## PRODUCT / PROCESS CHANGE NOTIFICATION

1.1 Company	 STMicroelectronics International N.V
1.2 PCN No.	MDG/23/13947
1.3 Title of PCN	ST25R3914-AQWT wafer fab / EWS dual source and datasheet update
1.4 Product Category	ST25R3914-AQWT
1.5 Issue date	2023-03-27

### ST25R3914-AQWT wafer fab / EWS dual source and datasheet update

#### What is the impact of the change?

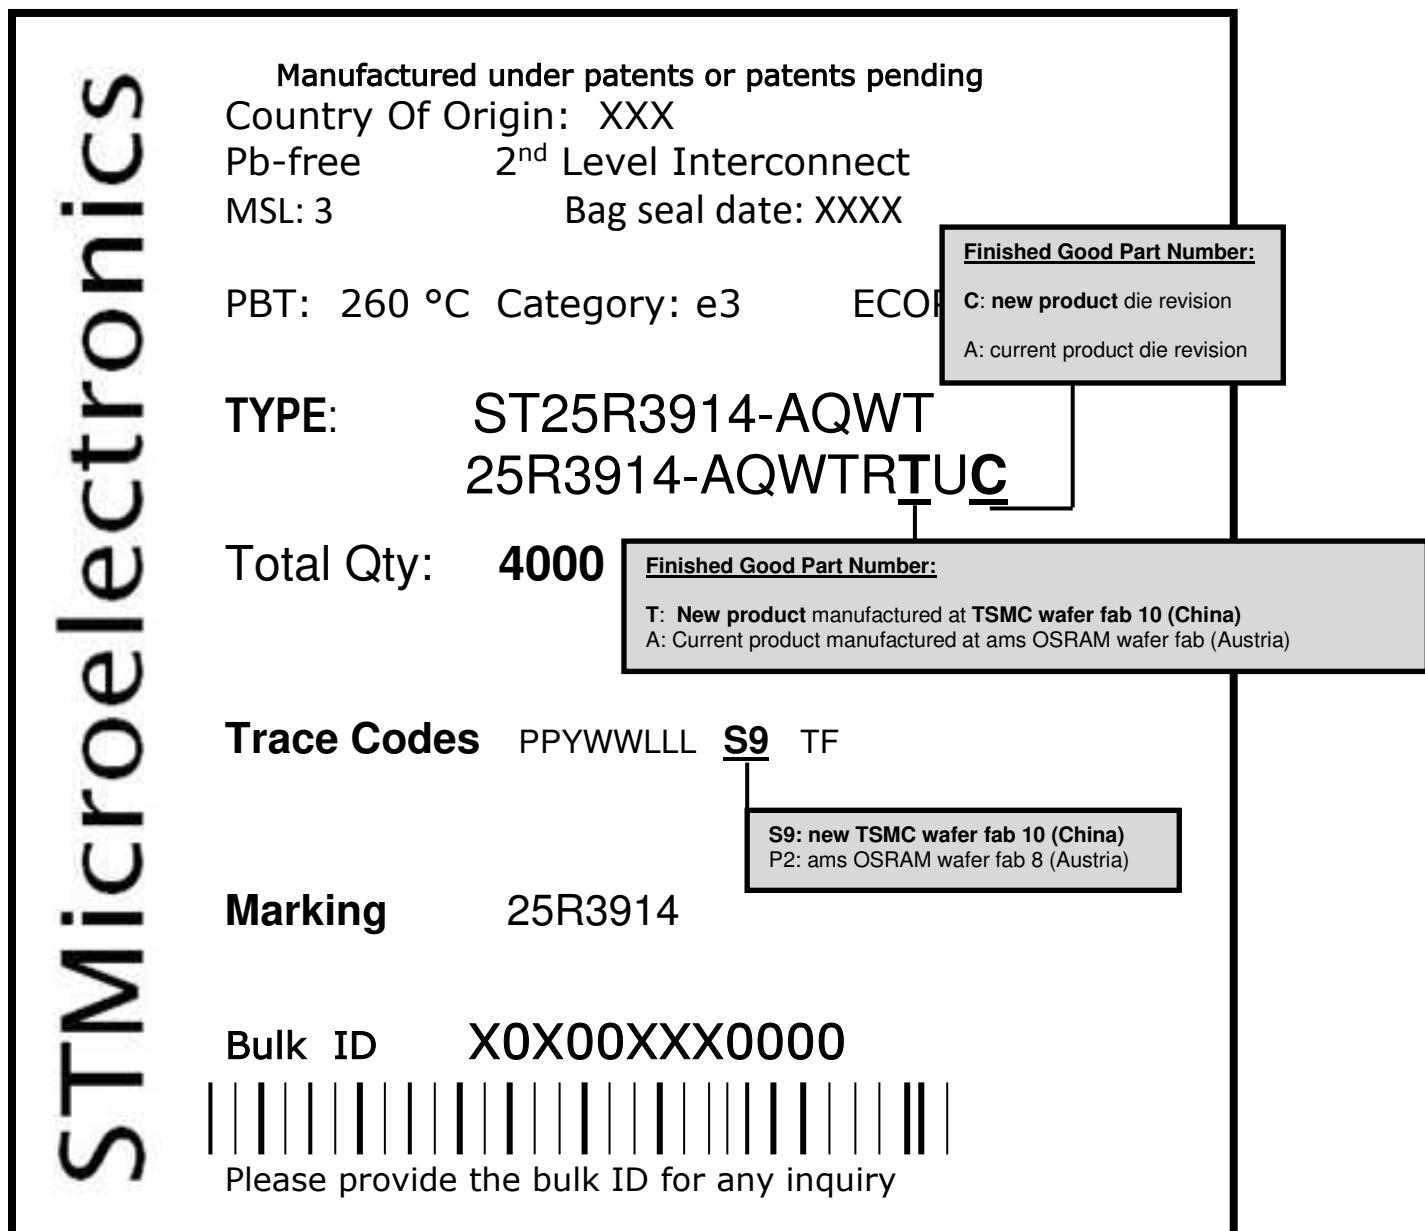
- Form:** Marking change to reflect the different Fab location
- Fit:** No change
- Function:** No change, except register 0x3F readout. Readout changed from 0Bh to 0Dh.

### - Form: DEVICE MARKING

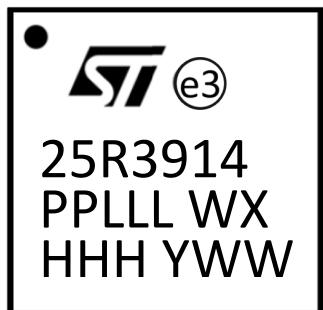
On the device marking, the change is visible inside the trace code where the **wafer fab country & plant** code “WX” is changing from P2 to **S9**.
